ADDENDUM NO. 2

Rochester City School District

Dr. Walter Cooper, School #10

February 28th, 2018

AD2-H004 DRAWING NOTES

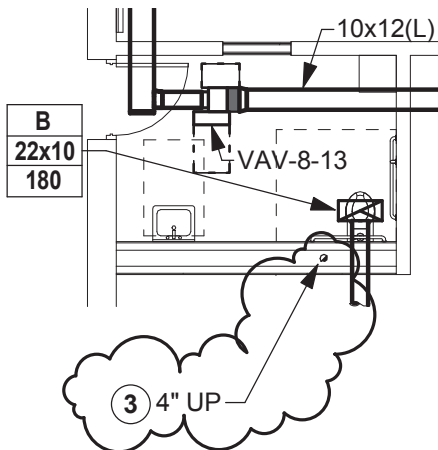
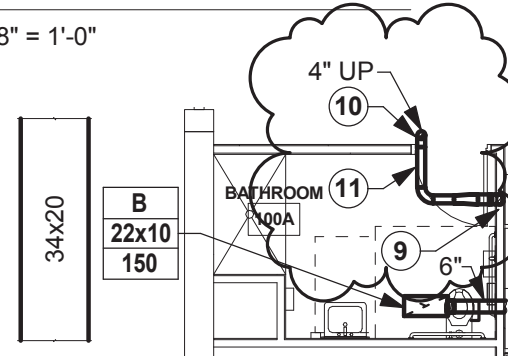
- Item AD2-33 **ADD** attached sketch “AD2-H004 – PARTIAL FLOOR PLANS – HVAC DUCTWORK.” Add dryer exhaust ductwork and accessories.

AD2-E002

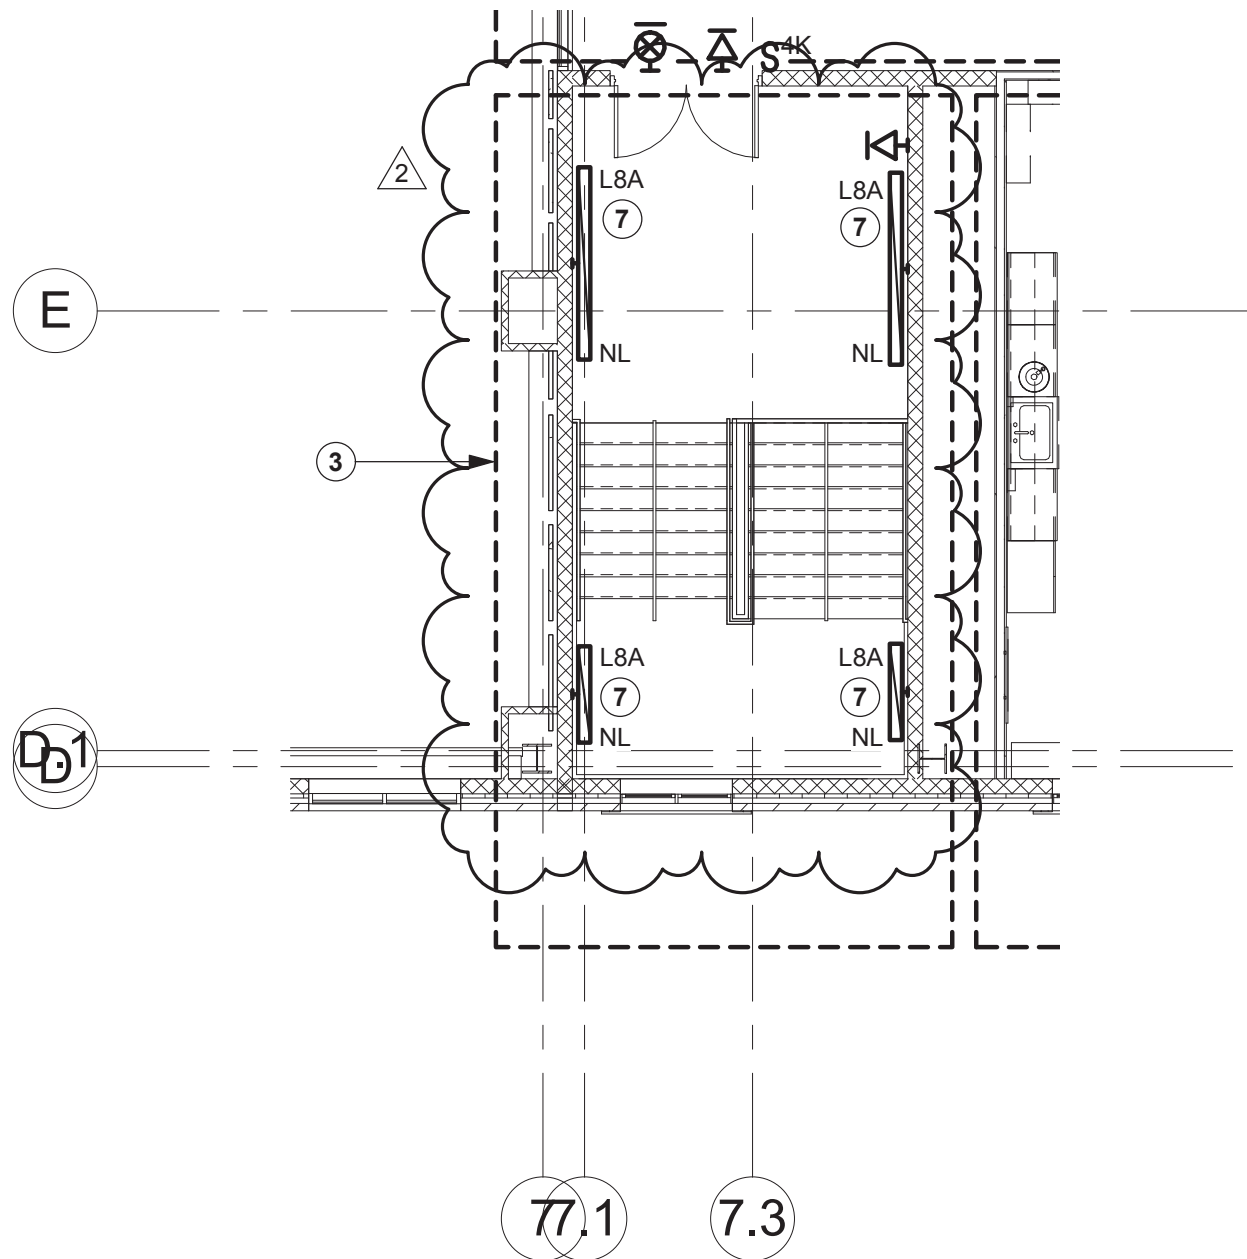
- Item AD2-69 **ADD** Drawing Note 7 to read as follows:
"MOUNT FIXTURE 8' AFF."
- Item AD2-70 **ADD** attached sketch "AD2-E002 - PARTIAL SECOND FLOOR PLAN - LIGHTING," revising lighting and associated drawing notes in Stair ST01.

AD2-E003

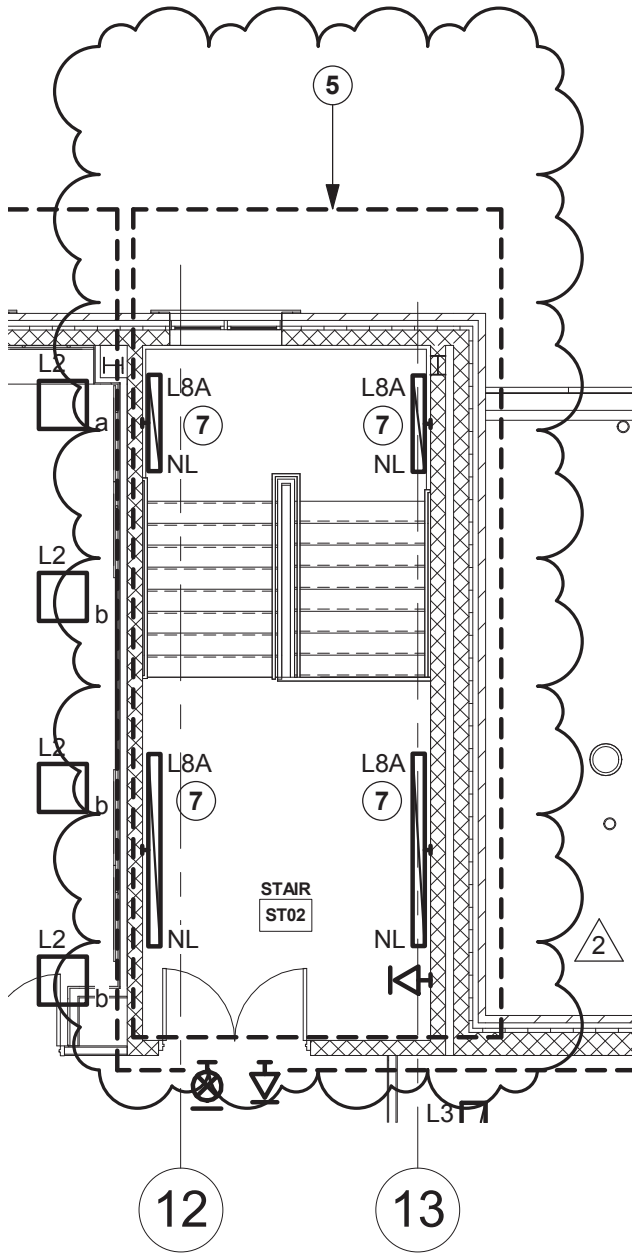
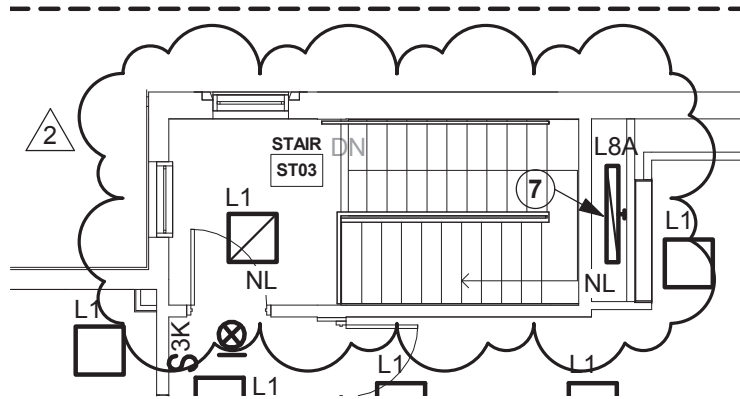
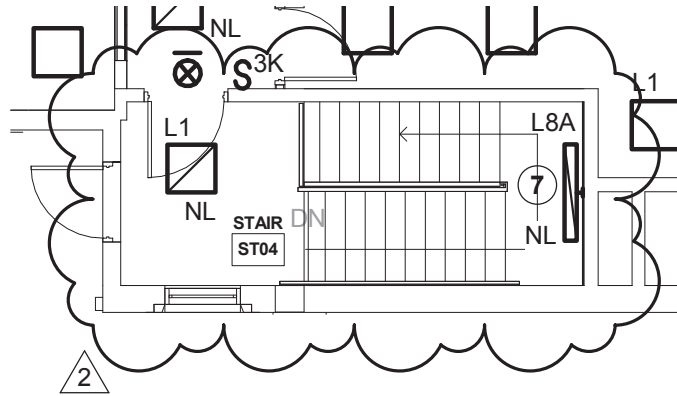
- Item AD2-74 **ADD** Drawing Note 7 to read as follows:
"MOUNT FIXTURE 8' AFF."
- Item AD2-75 **ADD** attached sketch "AD2-E003 - PARTIAL SECOND FLOOR PLAN - LIGHTING," revising lighting and associated drawing notes in Stairs ST02, ST03, and ST04.

AD2-E004

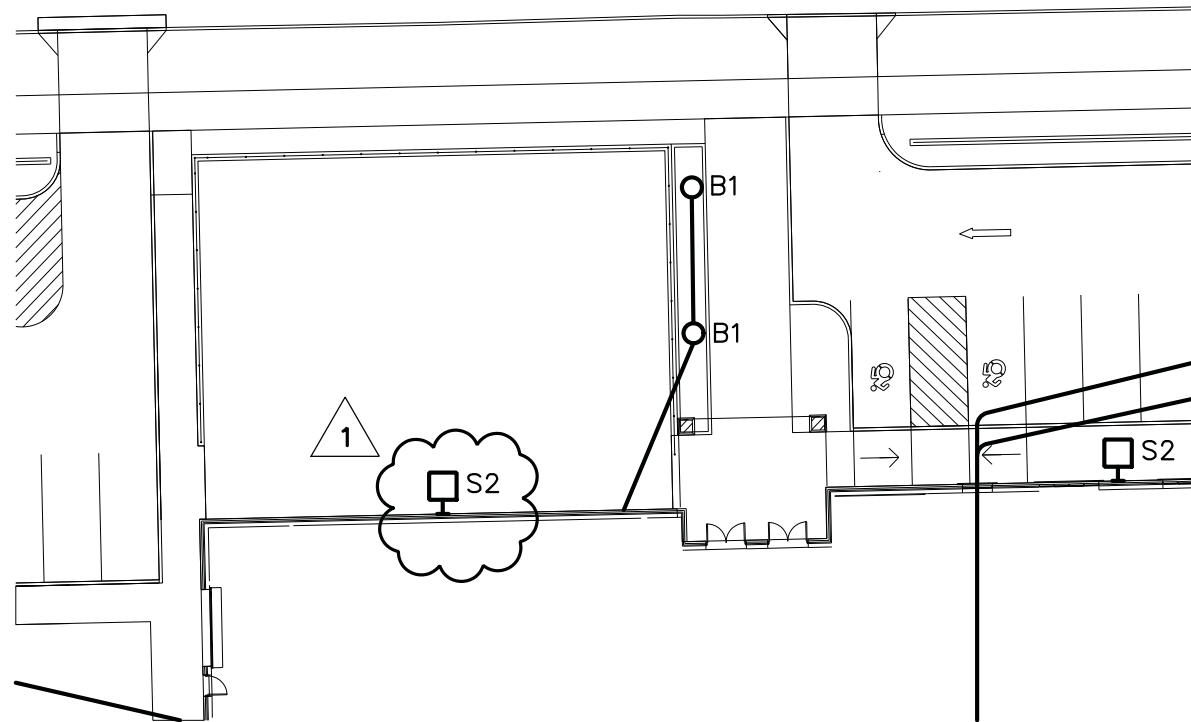
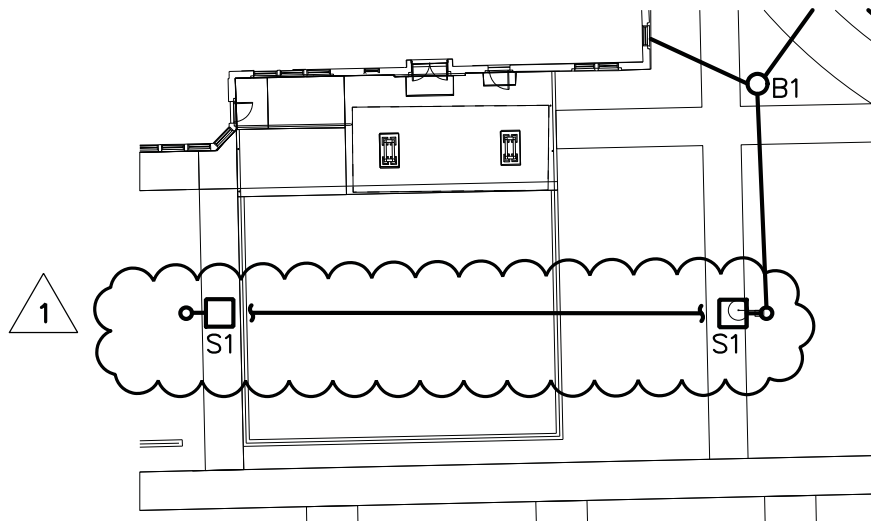
- Item AD2-76 **ADD** attached sketch "AD2-E004 - PARTIAL SITE PLAN - ELECTRICAL," adding lighting and associated circuit routing.
- Item AD2-77 **REVISE** General Note B in its entirety to read as follows:
"ALL 277V NORMAL POWER SITE LIGHTING SHALL BE CONNECTED TO PANELBOARD HVPBR, 20A CIRCUIT #5, AND CONTROLLED BY THE EXTERIOR LIGHTING CONTROL CONTACTOR. PROVIDE BRANCH CIRCUIT USING 2#8, 1#8G, 1"C."
- Item AD2-78 **ADD** attached sketch "AD2-E009 - PARTIAL SITE PLAN - ELECTRICAL," adding the electrode ground grid location.

AD2-E008

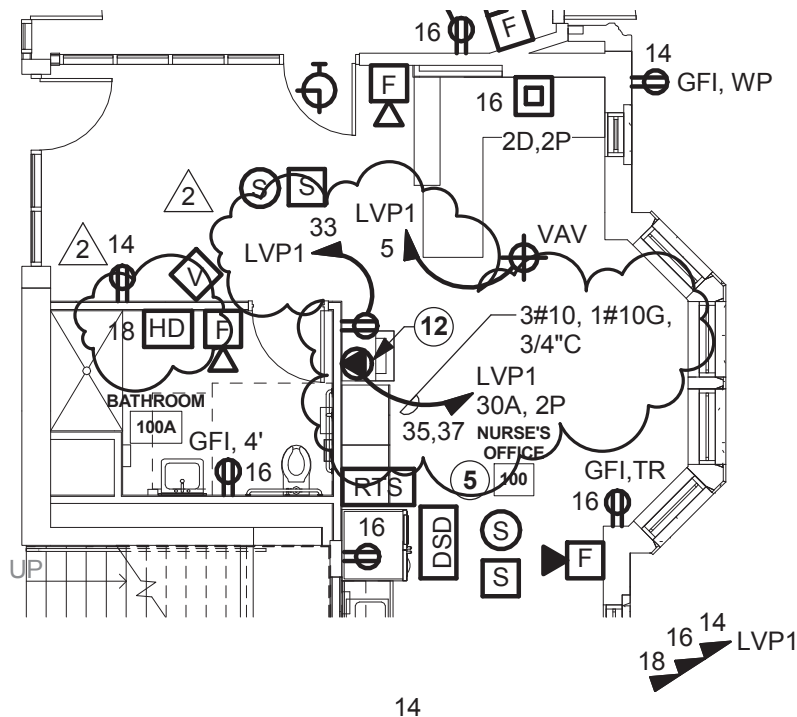
Item AD2-49 **ADD** attached sketch "AD2-E008 - PARTIAL FIRST FLOOR PLAN - POWER AND SS," adding and removing receptacles and associated circuiting and notes.

AD2-E011

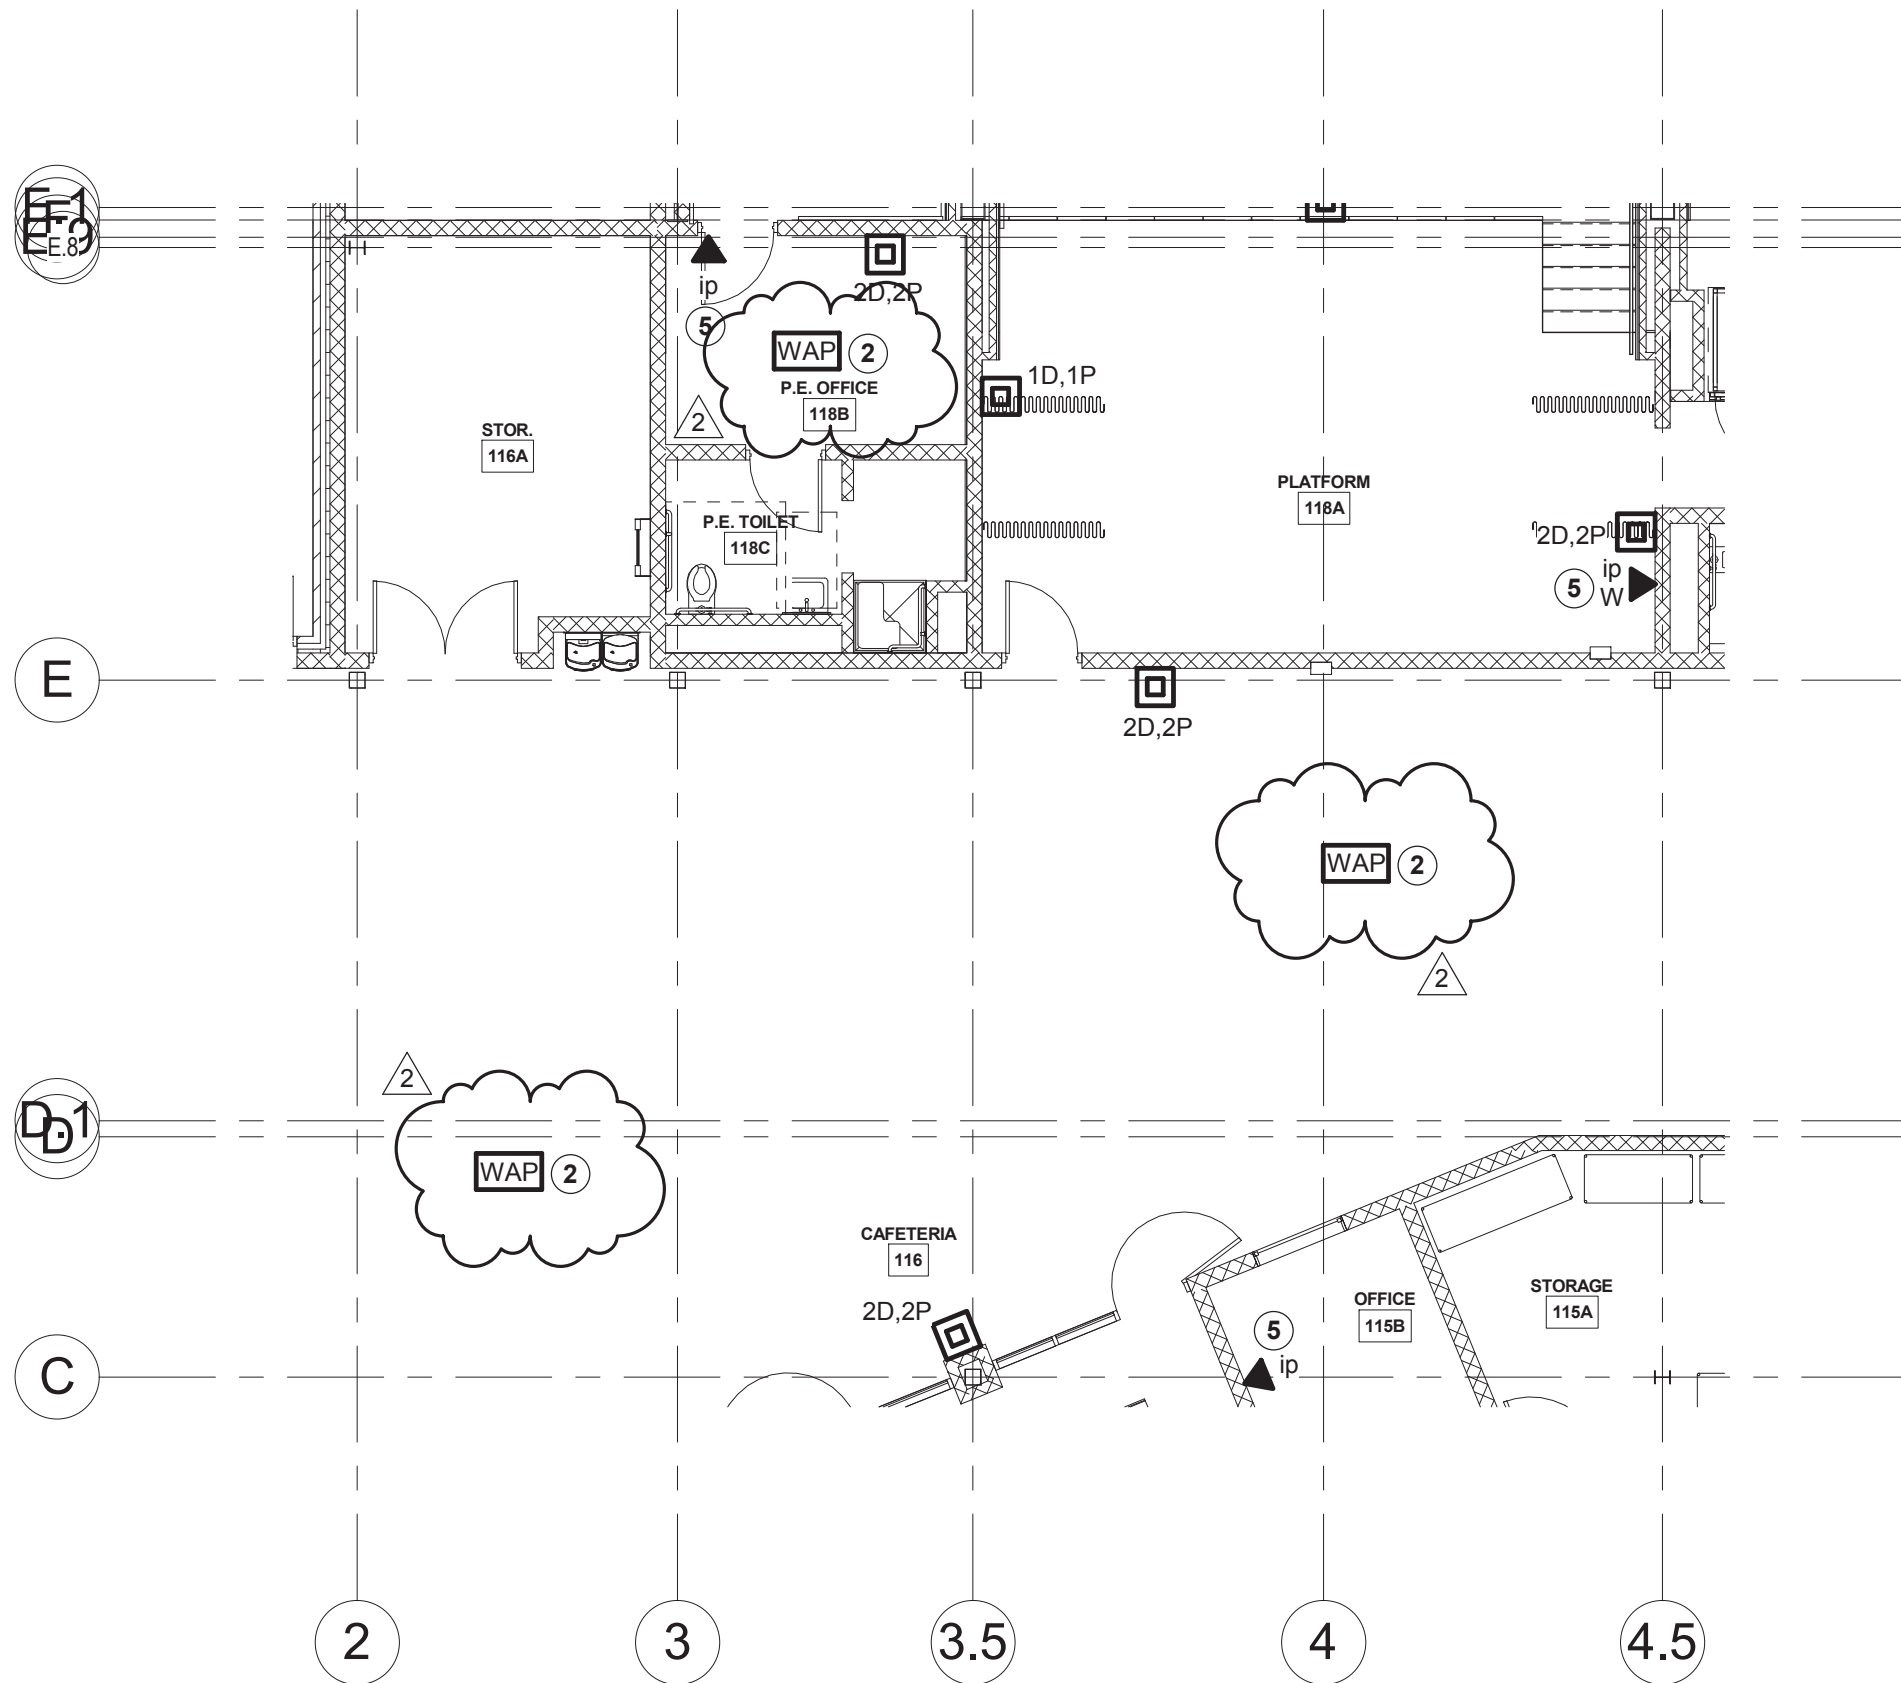
Item AD2-82 **ADD** attached sketch "AD2-E011 - PARTIAL FIRST FLOOR PLAN - DWT," adding wireless access points.
